PROJECT NAME: MSP 9025-0636-17

PROJECT NUMBER: 2024080059

APPLICATION: MINOR SITE PLAN #31903

SHEET C001

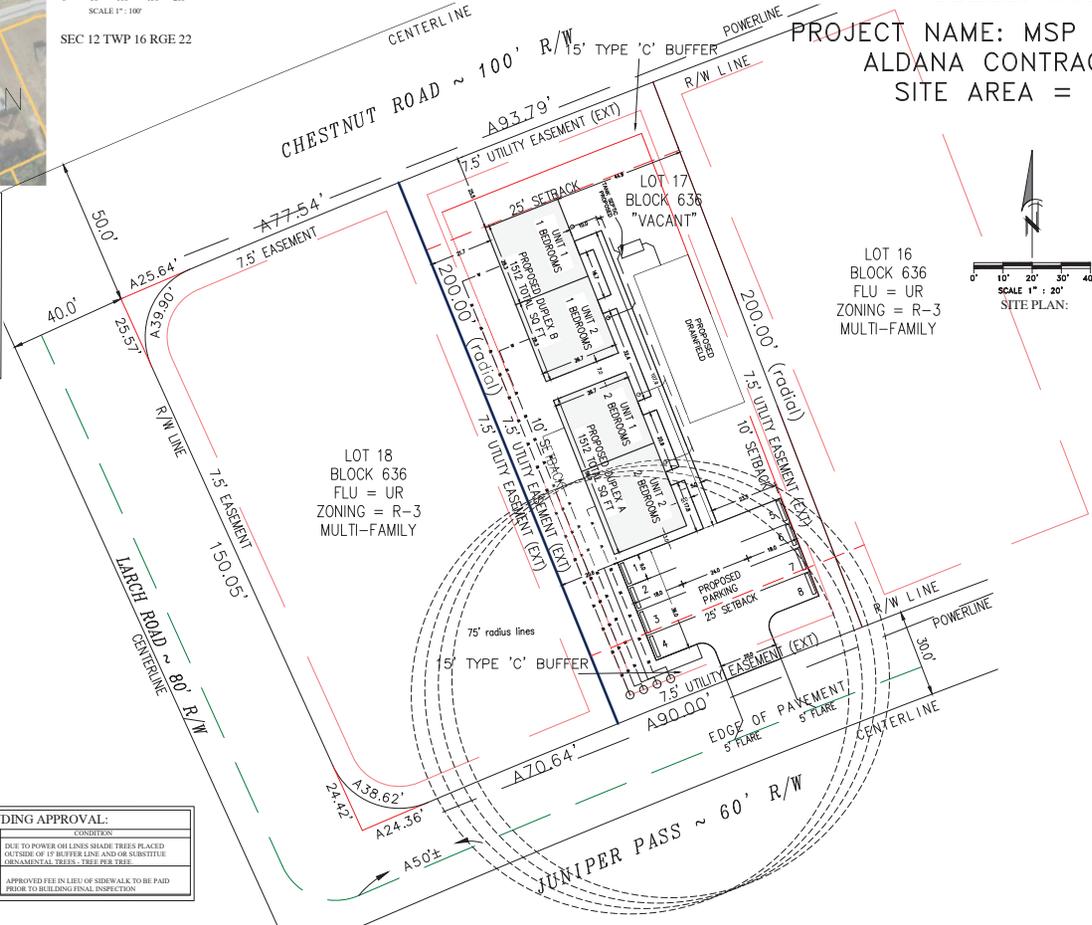
- 20 DEPARTMENT: 911 - 911 MANAGEMENT  
REVIEW ITEM: Additional 911 comments  
STATUS OF REVIEW: NO  
REMARKS: Sheet C001 –Site Data – Intended Use for this Site should be 2 duplexes not 1, The Section is incorrect as 12, it should be 13, Sheets C002 & C003 – Title Bar - Parcel is incorrect as 8009-1274-41 and Section Township and Range is incorrect as 23-17-21, it should be 13-16-22.

LANDSCAPE PLAN:  
 SCALE: 1" = 20'

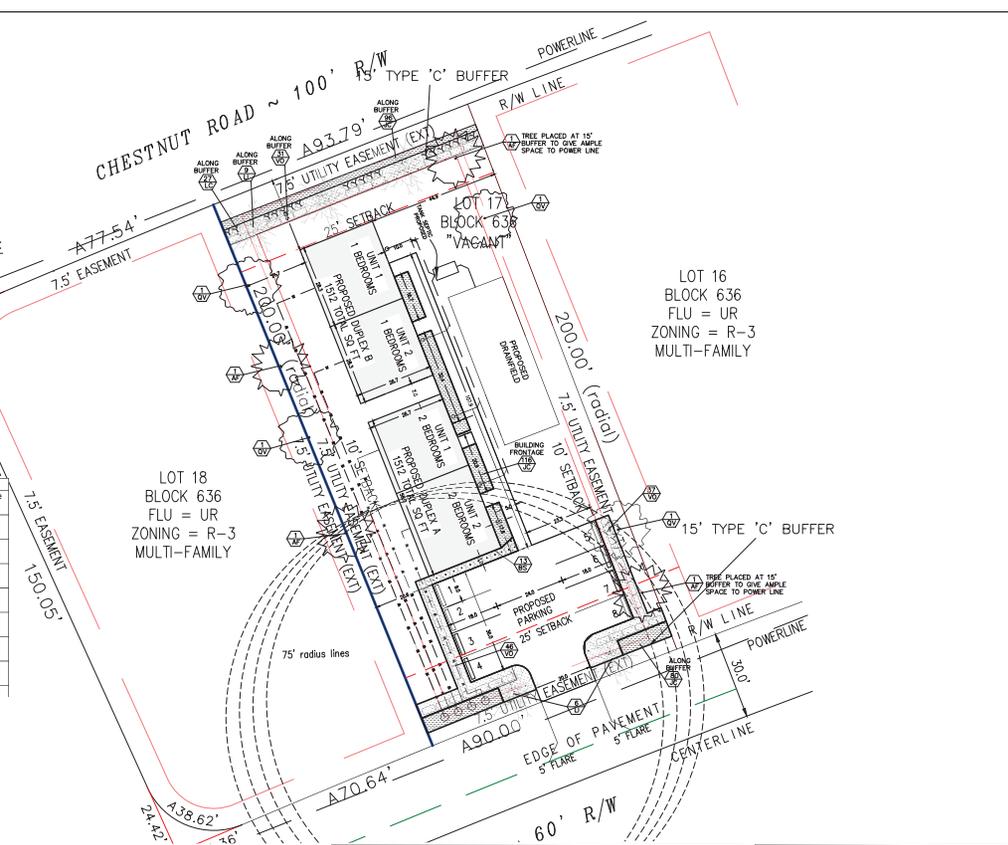
- 23 DEPARTMENT: LSCAPE - LANDSCAPE DESIGN AND IRRIGATION  
REVIEW ITEM: 6.8.2 - Landscape plan requirements (details, schedule, calculations, notes)  
STATUS OF REVIEW: NO  
REMARKS: 1. Hatched area in buffer in key is spartina bakeri, label on plan is JC - please clarify 2. BS labeled as 13, only 7 shown
